Pre-Preliminary Plan No. 720130100: Pleasant Plains, Lot 4

Description

Staff Recommendation: *Approval with conditions*

PRELIMINARY PLAN
PLEASANT PLAINS LOT 4
 7300 HAVANA COUNTRY ROAD
 AVONDALE, FL 33003
 VANANIAN, INC.
 Registered Surveyors & Planners
 12345 AVONDALE BLVD., SUITE 100
 AVONDALE, FL 33003
 SHEET 1 OF 1
 8/25/2024

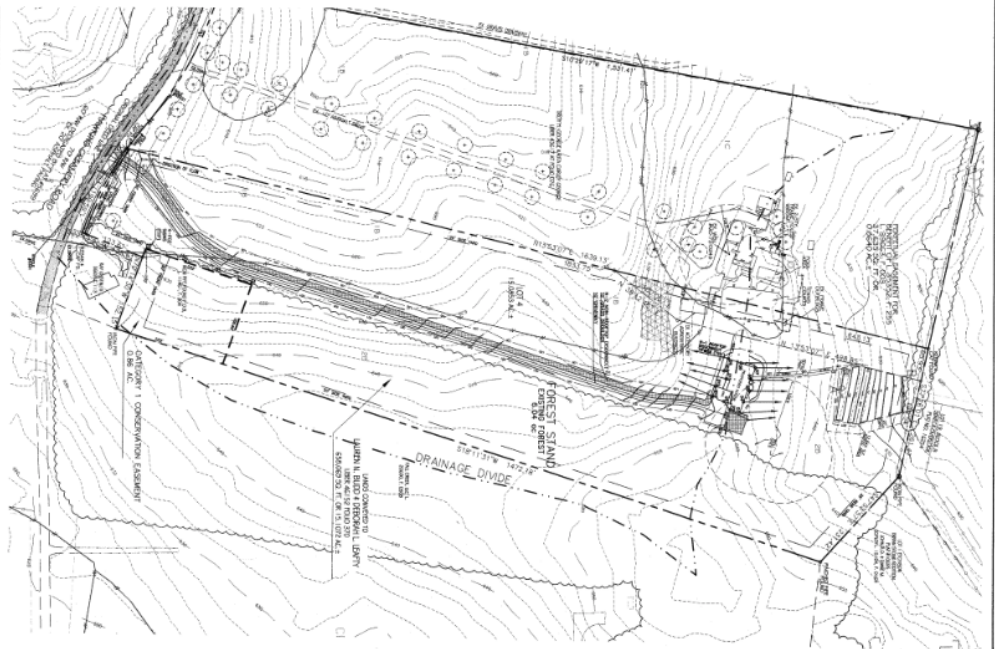
1. The record plat must be at the same scale as the preliminary plan, or submit an enlargement of the plat to match the preliminary plan.
2. All new septic systems must utilize Best Available Treatment (BAT) as defined by State of Maryland (MDE) regulations.
3. Storm-water management structure locations must meet applicable setbacks from the septic areas.

1. Dedicate necessary right-of-way in accordance with the Master Plan for Hawkins Creamery Road.
2. Grant a Public Improvements Easement (PIE) along the site frontage in accordance with roadway standard MC-212.05 "Master Plan Primary Road". The standard can be viewed on-line at: http://www.montgomerycountymd.gov/dot-traffic/development_review.html under the Context Sensitive Road Design Standards Link.

3. The Declaration of Public Improvements Easement document is to be recorded in the Land Records of Montgomery County. The deed reference is to be provided on the record plat. Unless otherwise noted, the Public Improvements Easement is to be a minimum width of nine (9) feet with the overlapping Public Utilities Easement being no less than nineteen (19) feet wide.

4. Grant necessary slope and drainage easements to accommodate PIE and grading per roadway standard MC-212.05.
5. The owner will be required to furnish this office with a recorded covenant whereby said owner agrees to pay a prorata share for the future construction or reconstruction of Hawkins Creamery Road whether built as a Montgomery County project or by private developer under permit, prior to DPS approval of the record plat. The deed reference for this document is to be provided on the record plat.
